UNITED STATES PATENT AND TRADEMARK OFFICE

| APPLICATION NO. | FILING DATE | FIRST NAMED INVENTOR | ATTORNEY DOCKET NO. | CONFIRMATION NO. |
|-----------------|-------------|----------------------|---------------------|------------------|
| 10/687,933 | 10/20/2003 | Helmut D. Link | 246472006000 | 8319 |

Office Action Summary

DETAILED ACTION

Figure 1

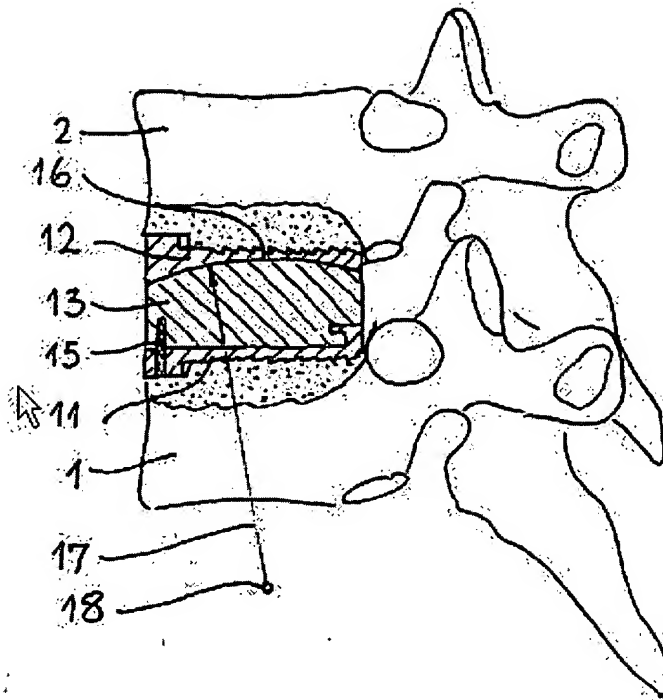
First, by way of clarification of terminology used by Applicant, the following is noted. Figure 1 of Applicant's invention, reproduced below, shows *slide surface radius* 17. The slide surface radius extends from the *center of hinge movement* 18 to the slide surface. Thus, slide surface radius is inextricably defined with respect to the center of hinge movement. Therefore, it necessarily follows that if the different prostheses have different slide surface radii of curvature (which they do in Berry, as set forth above), they must also have corresponding different centers of hinge movement. Therefore, any argument that Berry does not disclose "centers of hinge movement" is without merit.**

** It is noted that "*hinge radius*" is another measurement and is not set forth in the remaining rejected claims and should not be confused with *center of hinge movement* or *slide surface radius*. However, even if *hinge radius* were in the claims, again, it would inherently be set forth, since it is defined as the distance from the *center of hinge movement* to the geometric midpoint of the prosthesis.
